Title: Riverdale Sewer Lift Station- Pressing Need Repairs
Charles R. Underwood Inc.

Re: Riverdale Pump Station
Pump Vibration Analysis and Remediation
Change Order No. 1

Contract Name: Vibration Analysis and Remediation

Work Change Directive No. 001

10 MGD Wemco-Hidrostal Pumps and Drive Shafts

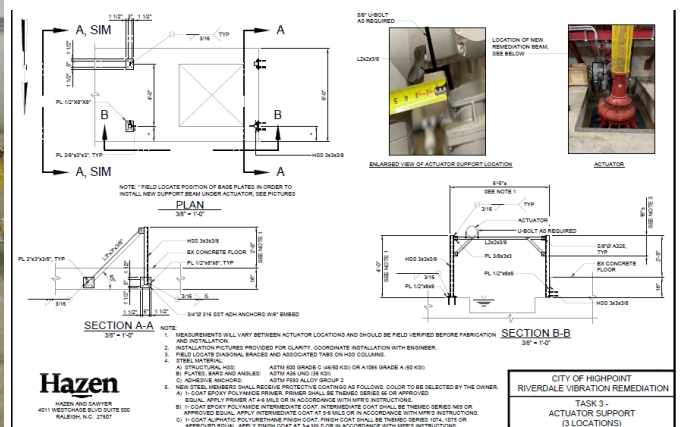
To approve Change Order No. 1 to Charles R. Underwood Inc. (PO # 104331) for additional materials and work outside of the scope of work for the pressing need repairs to the existing pumps in the dry well of the Riverdale Pump Station.

Phase I of the expansion project for the Riverdale Pump Station was recently completed. The three existing 10 MGD Wemco-Hydrostal pumps (installed in 1996) were not replaced as part of the phase I expansion project. After the pump station was brought back online, Plant Maintenance staff observed significant vibration from the pumps and also discovered that the 18” discharge valves for the pumps were not holding. Charles R. Underwood Inc. was hired under a pressing needs situation to perform work on the three pumps including fabricating and installing restraint supports and replacing the existing 18” discharge valves. The amount of PO # 104331 was \$89,500. Change Order No. 1 is for additional items required to complete the project including the replacement of drive shafts for pumps #2 and #3.
